# UNITED STATES PATENT AND TRADEMARK OFFICE

APPLICATION NO.	FILING DATE	FIRST NAMED INVENTOR	ATTORNEY DOCKET NO.	CONFIRMATION NO.
10/509,478	09/29/2004	Marten Erik Van Dijk	NL 020269	1367

<b>Office Action Summary</b>	Application No. 10/509,478	Applicant(s) VAN DIJK ET AL.	
	Examiner Mujtaba K. Chaudry	Art Unit 2133

## **DETAILED ACTION**

Fig. 7

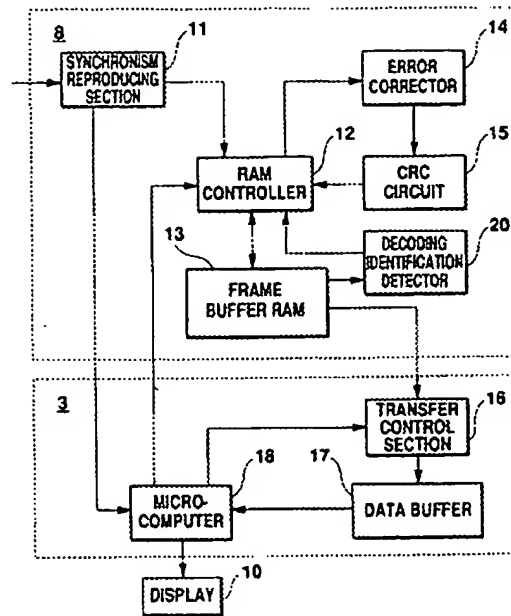
However, Kimura et al. (herein after referred to as single entity: Kimura) in an analogous art, substantially teaches (Figure 7) a digital signal is composed of a frame which consists of a predetermined number of blocks in the vertical direction, a block consisting of a predetermined number of bits in the horizontal direction and having a horizontal parity (error correcting code) for correcting error in the horizontal direction and a vertical parity for correcting errors in the vertical direction. The block also has a control bit for determining whether the error correction in the horizontal direction is to be carried out only once. A decoding identification detector (20) detects the content of the control bit, a controller (12) controls the re-writing of the digital signal into a frame buffer (13) after the error correction of the digital signal in the vertical direction by an error corrector (14). The controller (12) also controls the provision of the digital signal stored

in the buffer (13) to the error corrector (14) according to the content of the control bit, determining whether the second error correction in the horizontal direction is to be carried out. Therefore it would have been obvious to one of ordinary skill in the art at the time the invention was made to embed horizontal parities within the shortened row code words within the method and apparatus of Kondo. This modification would have been obvious to one of ordinary skill in the art because one of ordinary skill would have recognized that by embedding horizontal parities within the shortened row code words would have increased the error detection and correction capability.
